## A. Engine 602, 603

### Differentiation of cylinder heads for naturally aspirated and turbo-engines

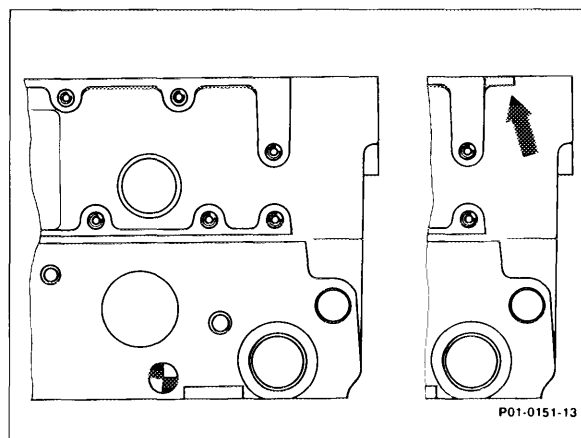
The cylinder heads for turbo-engines 602.96, 603.96 and 603.97 are reinforced at the water jacket due to the higher combustion pressures.

On turbo-engines the diameter (d) of the pre-combustion chamber bore is 15 mm, on naturally aspirated engines 14 mm.

The cylinder heads on turbo-engines are provided with an identification strip. This identification strip (arrow) is located on the parting surface for the cylinder head cover at the front right.

Do not mix up cylinder heads for turbo-engines and naturally aspirated engines.

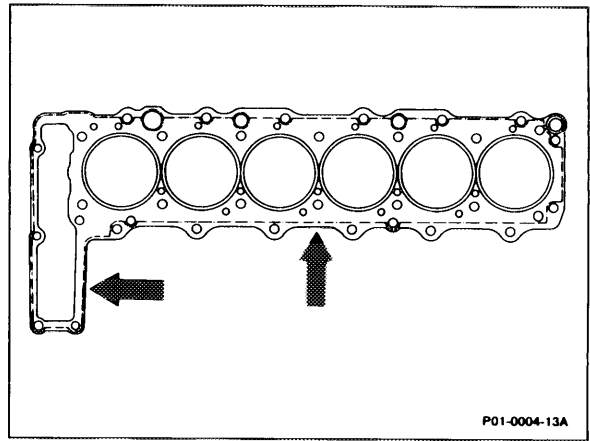
The cylinder head gasket for the turbo-engines has stainless steel inserts around the combustion chambers (arrow).

The combustion chamber inserts on the standard gaskets installed on naturally aspirated engines consist of normal sheet steel.

Only the cylinder head gaskets with stainless steel inserts are available as replacement parts for both the naturally aspirated and turbo-engines.

### Cylinder head gasket with Viton sealing ring

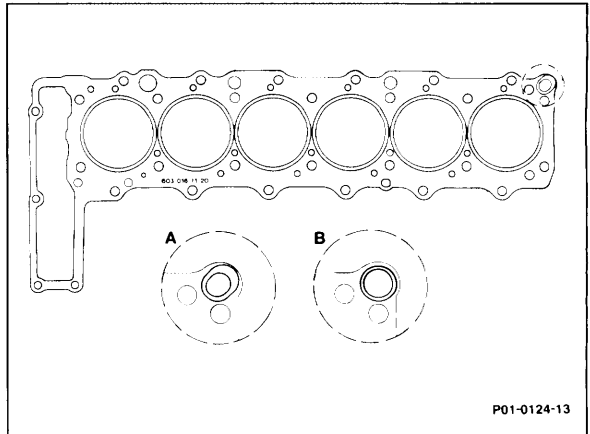
A Viton sealing ring is inserted at the rear oil return passage to prevent oil leakage.

- A 1st version with sheet metal jacket
- B 2nd version with Viton sealing ring

### Modifications in area of timing chain case

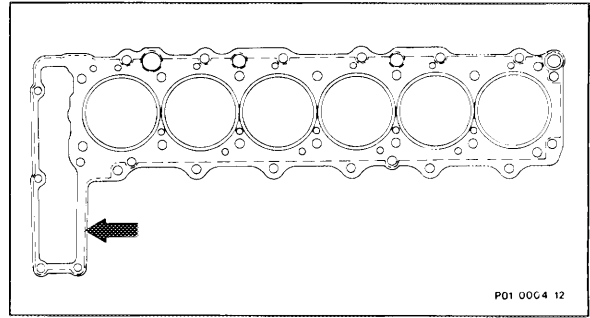
For production reasons the height of the bridge in the cylinder head in the area of the timing chain case was increased to 32 mm (previously 12 mm).

This modification made it necessary to change the dimensions of the two cylinder head bolts (arrow). The new bolt length is M 8 x 50 (previously M 8 x 30).

**Cylinder head gasket for improved sealing**

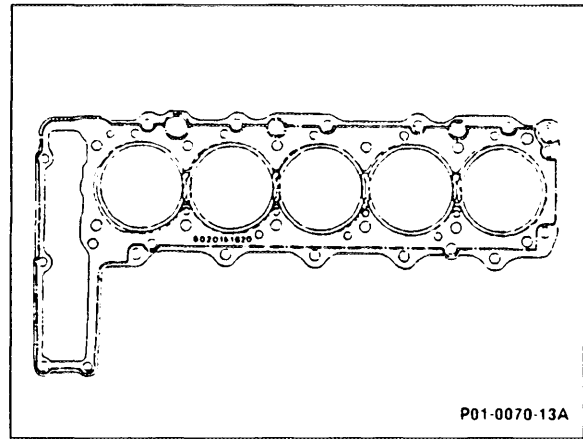
The cylinder head gasket has been equipped with circumferential silicone sealing strips (arrow) on both sides and a Viton sealing ring at the oil return passage at the rear right to better prevent water and oil leakage.

## Cylinder head gasket, engine 603.970

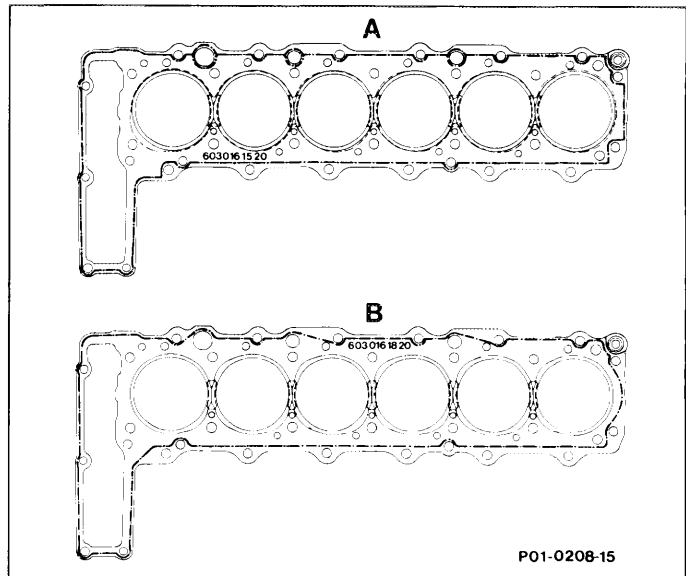
Combustion chamber insert modified.  
Silicone sealing strip position changed on both sides.

- A. 1st version (Götze)
- B. 2nd version (Ering)
